GARFIELD AVENUE LONG ISLAND  
97-B-50

AP Garfield Ave., Long Island  
Assessors #97-B-50

Permit to construct a 22'x28' frame shed for storage of household goods only as per your statement on signed application is being issued subject to our discussion of this date as follows:

PROPOSED STORAGE SHED

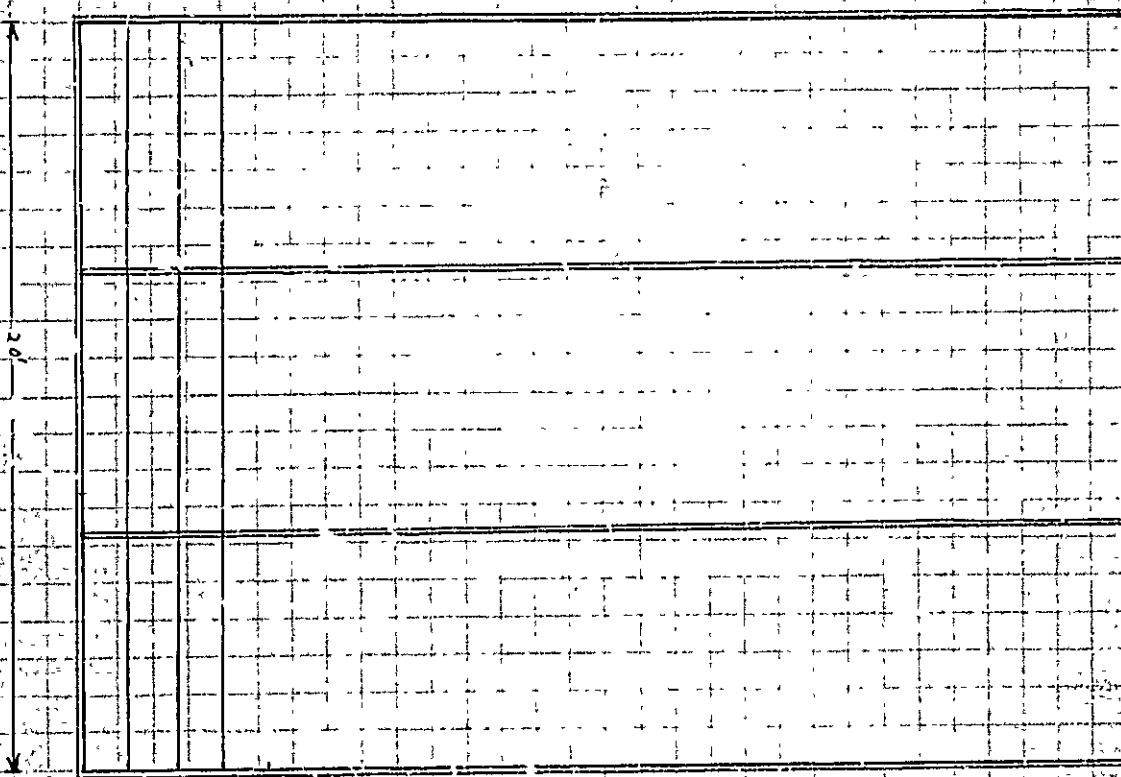
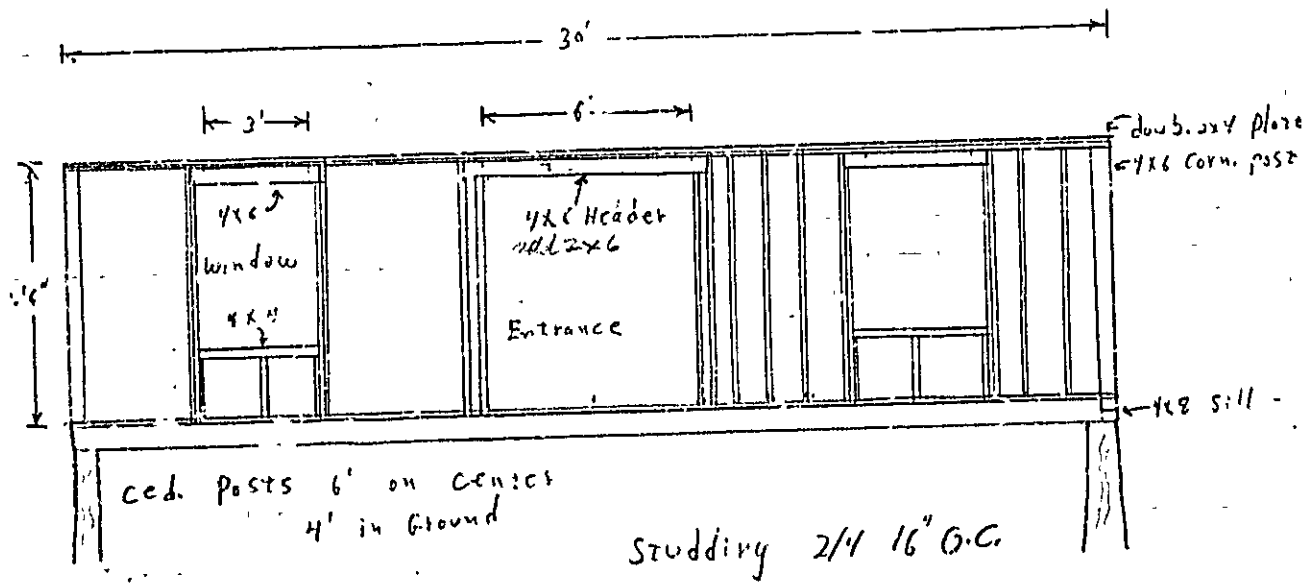
1. This building is to be 22'x28' in size instead of 22'x30' in size to comply with the Residence 3 Zone area requirements in which zone this building is located.
2. The pre-fabricated trusses are to be supported at the two panel points under the bottom chord by no less than 4x6 inch girders supported at every 10 feet by 4x4 inch posts.
3. There are to be 2x4 inch vertical struts added at the panel points above the 4x6 inch girders making the horizontal spans of each member of the top chord approximately 5 1/2 feet.
4. There is to be a 2x6 inch member added beside the existing 4x6 inch header over the 6 foot wide entrance door.
